GOVERNMENT OF MADRAS.
PUBLIC WORKS DEPARTMENT.

ORDER—dated 26th September 1895, No. 2381 W., Public Works.

The design applied for by the Superintending Engineer is now obsolete and a revised design recently prepared is circulated for adoption.

REVISED TYPE DESIGN FOR A DEPUTY TAHSILDARS OFFICE-TILED ROOFING.

(Signed) H. J. J. J.
Consulting Architect to Govt.

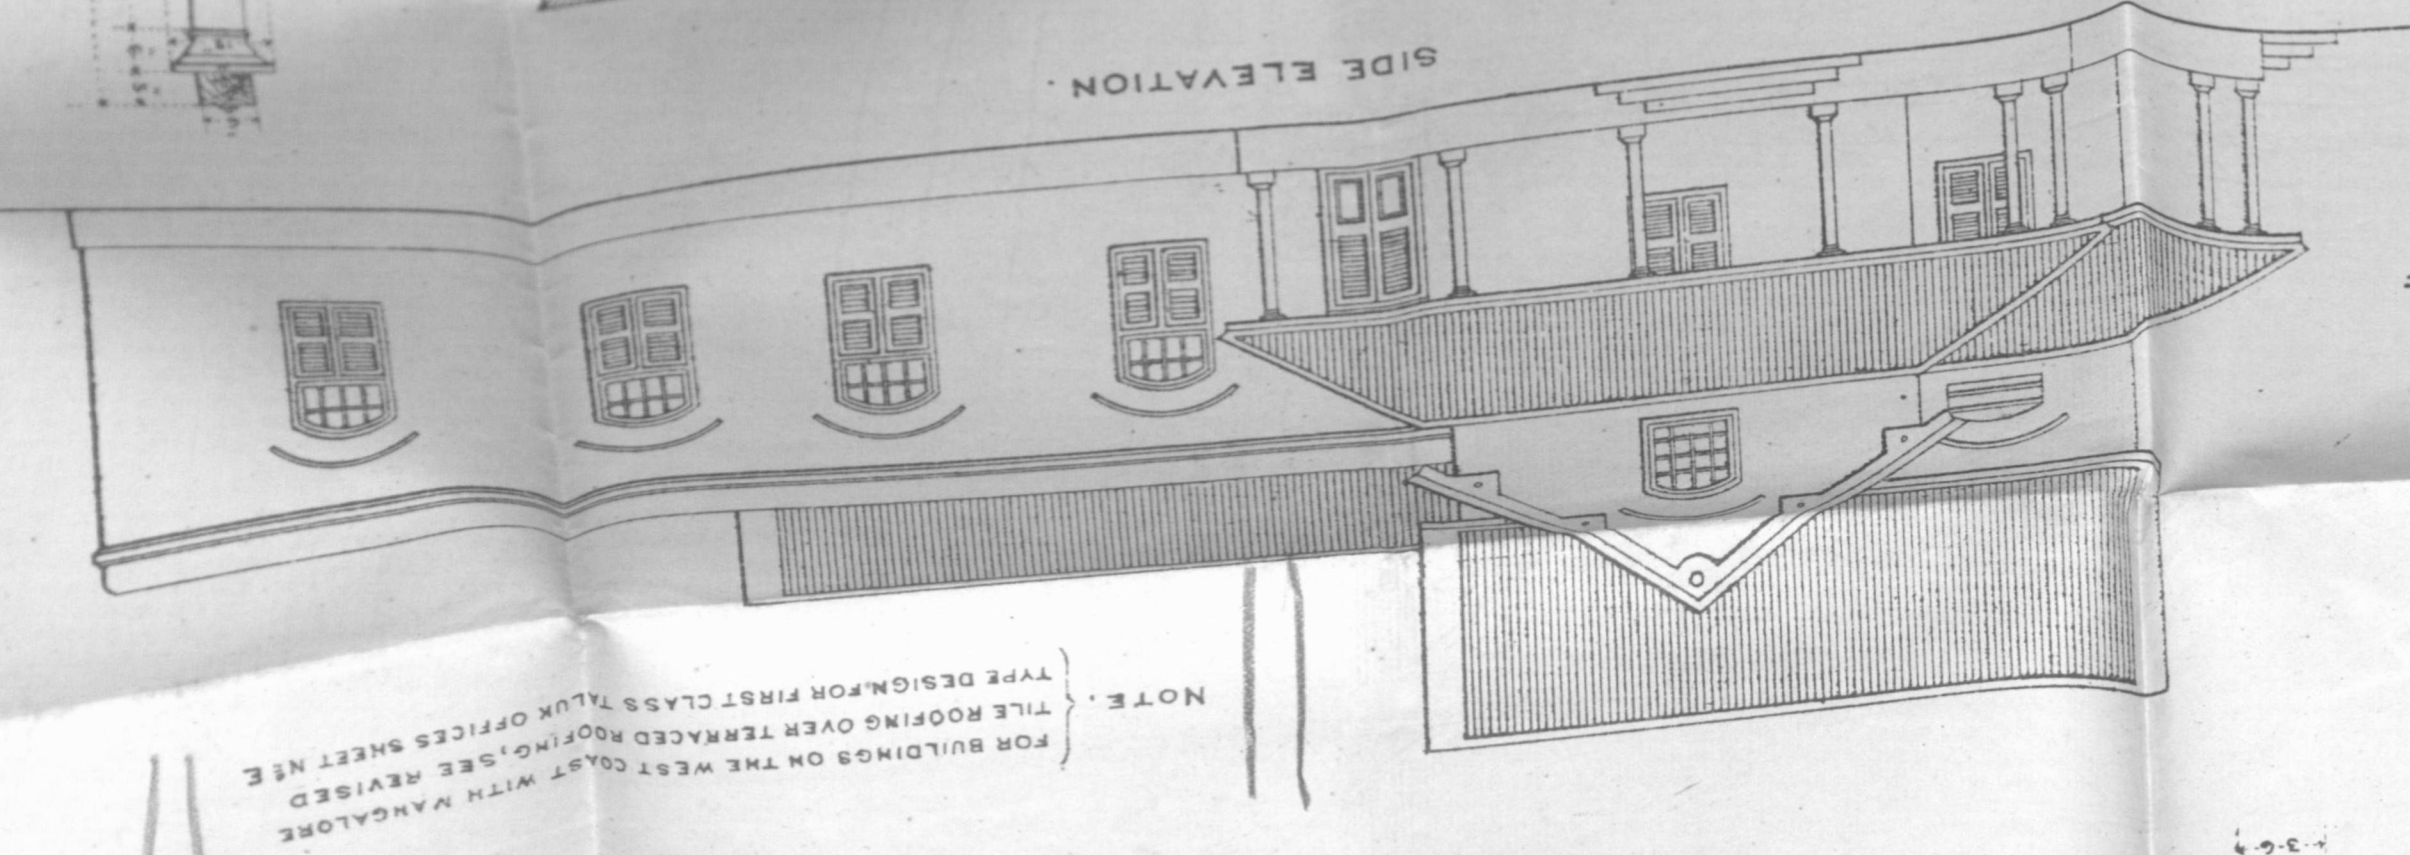
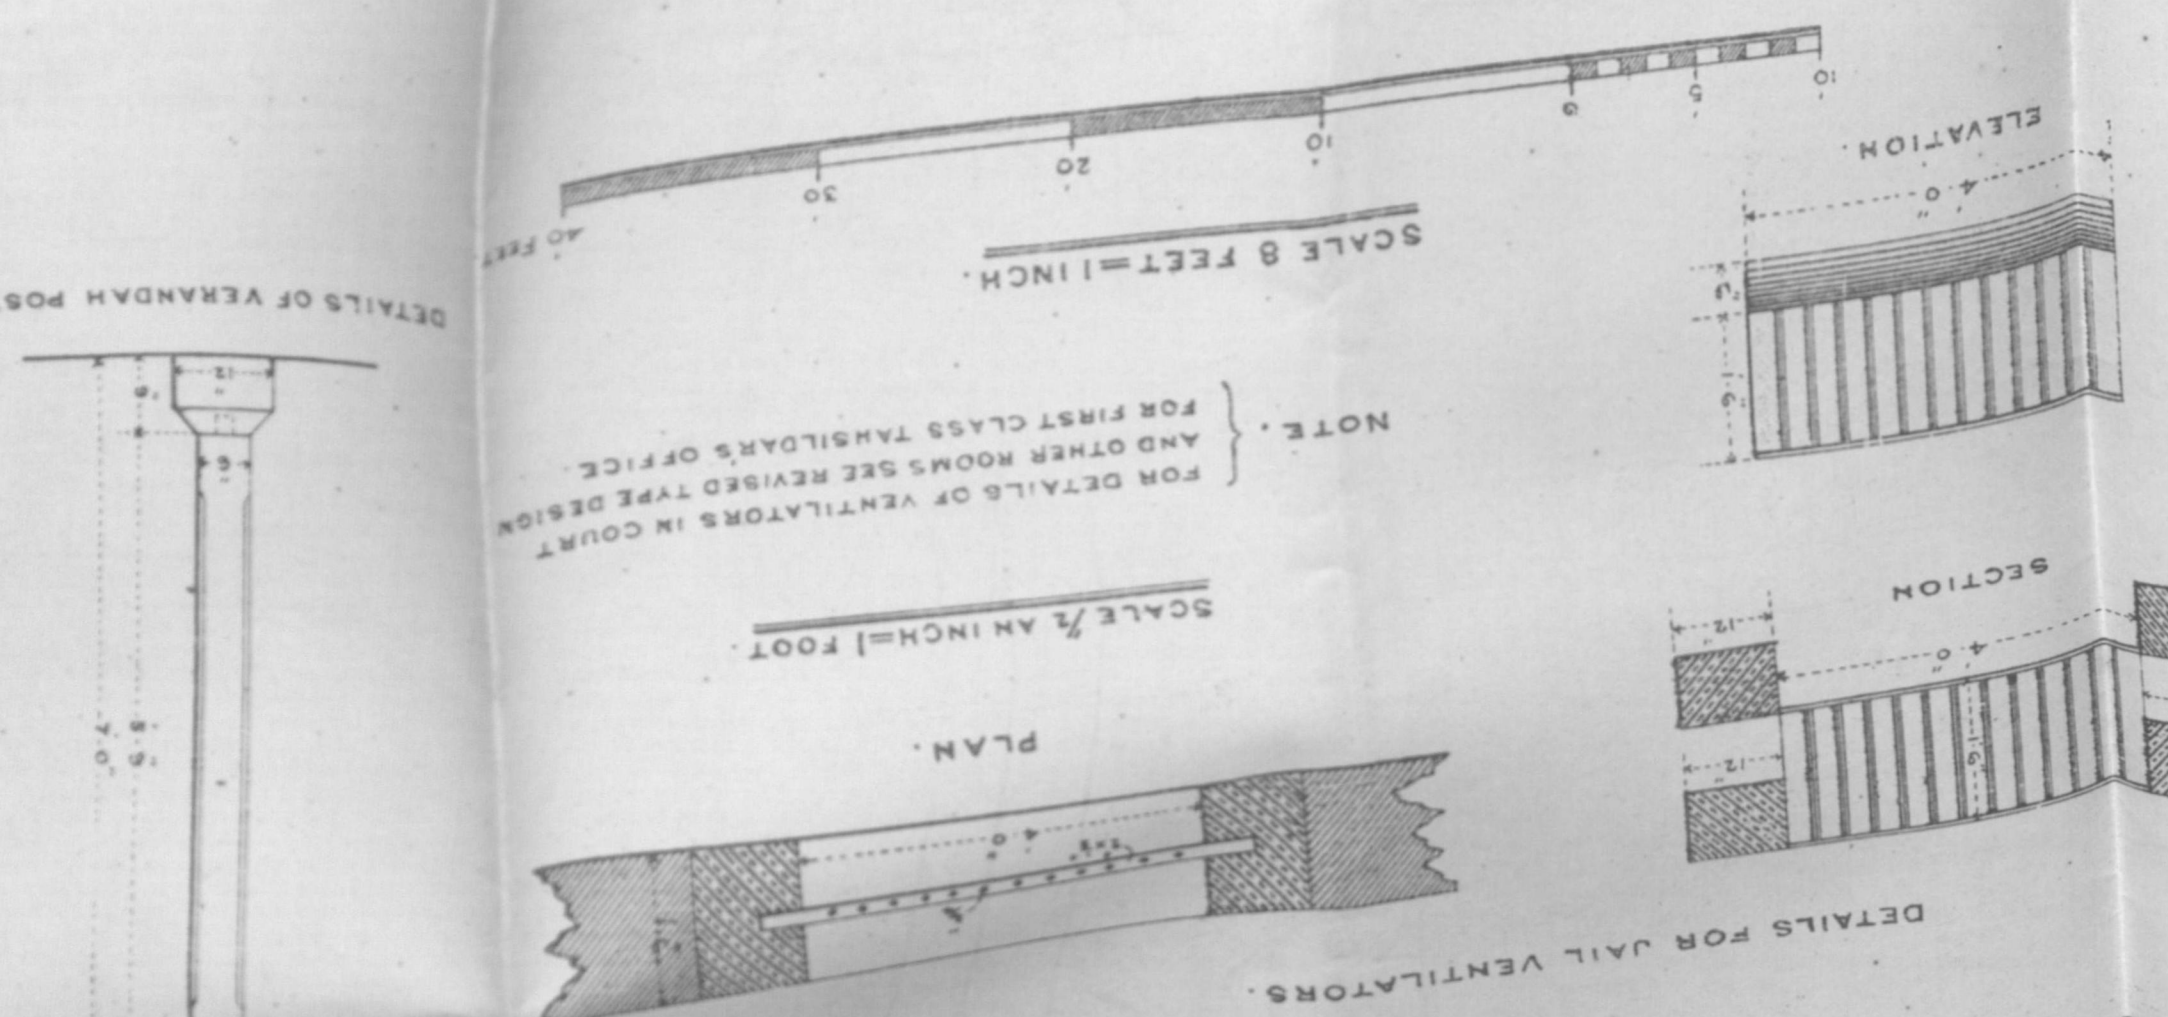
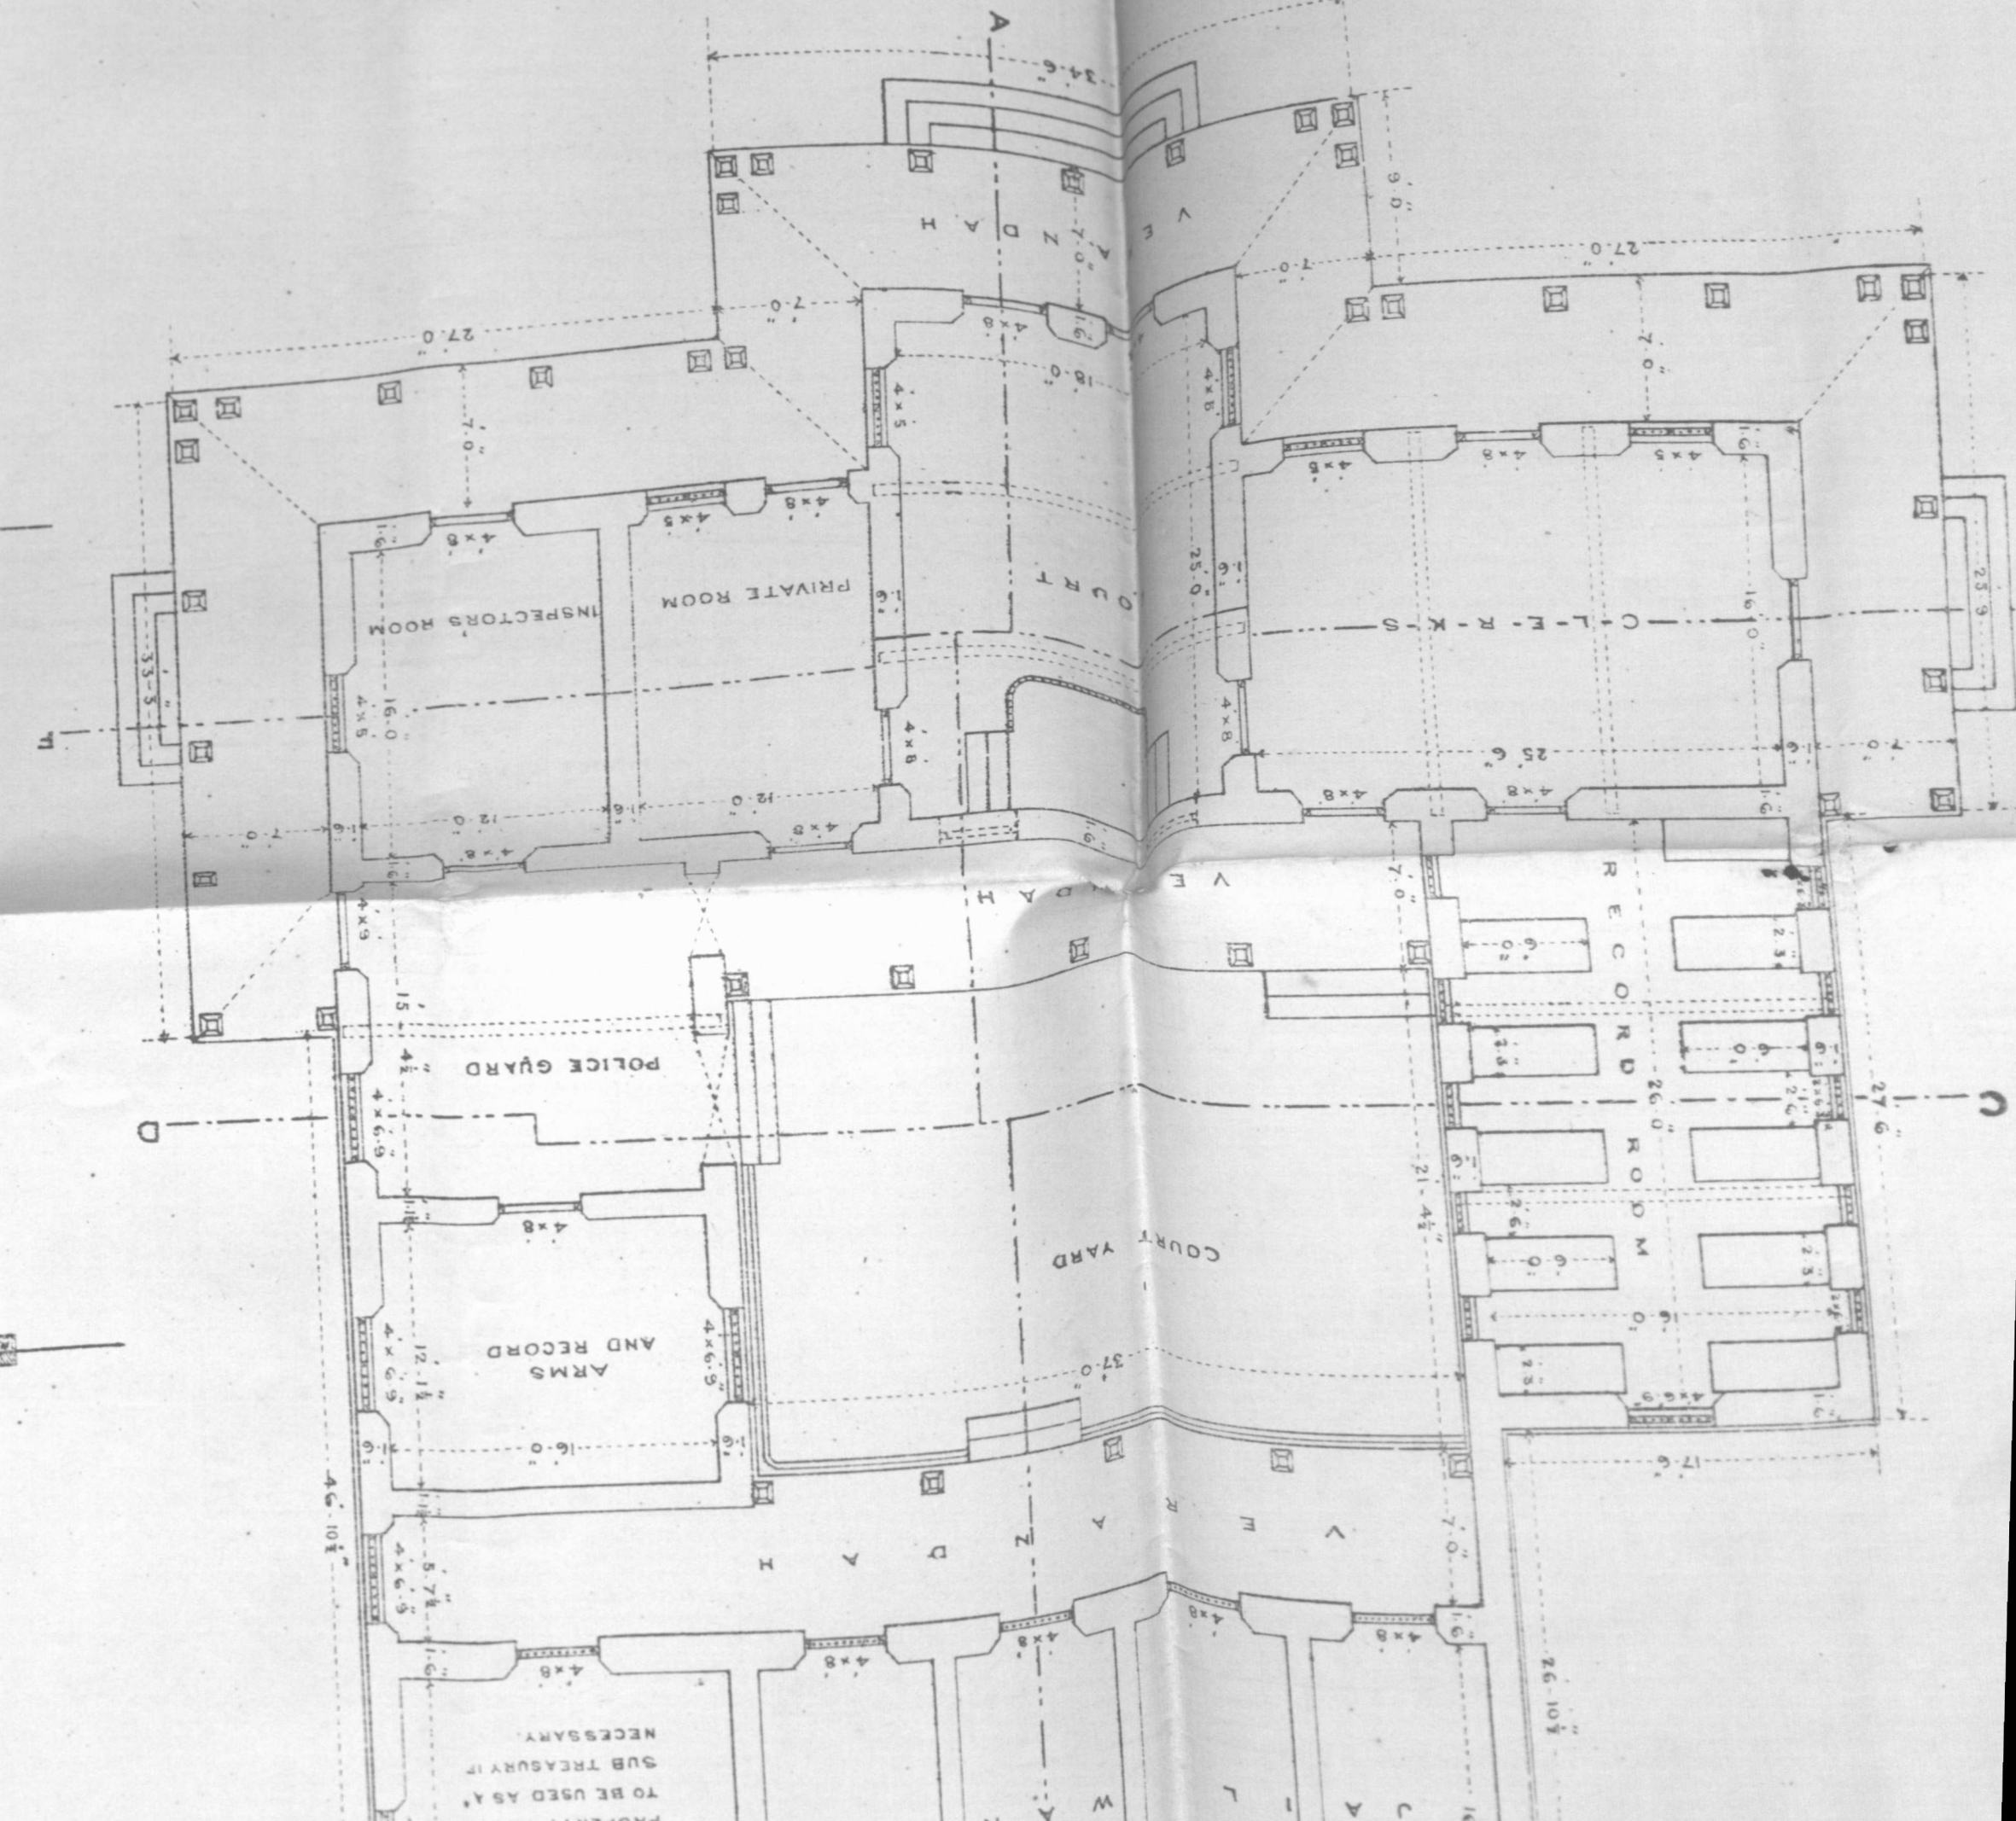
The revised design pro-
vides for the elongation
of the side verandah to the
police guard & altering
the position of steps at
sides, also it now shows
the elevation of the record room
the side elevation & the
position of fences on ground
plan.

NOTE. THE FOUNDATIONS AS SHOWN SHOULD NOT BE TAKEN AS A GUIDE. IT WOULD BETTER TO CONSTRUCT THEM OF CONCRETE TO GROUND LEVEL. THE CONCRETE TO BE 2 FEET, ONE FOOT ON EACH SIDE BROADER THAN THE MASONRY IMMEDIATELY ABOVE, AS SHOWN IN THE SKETCH. FOR EXAMPLE.
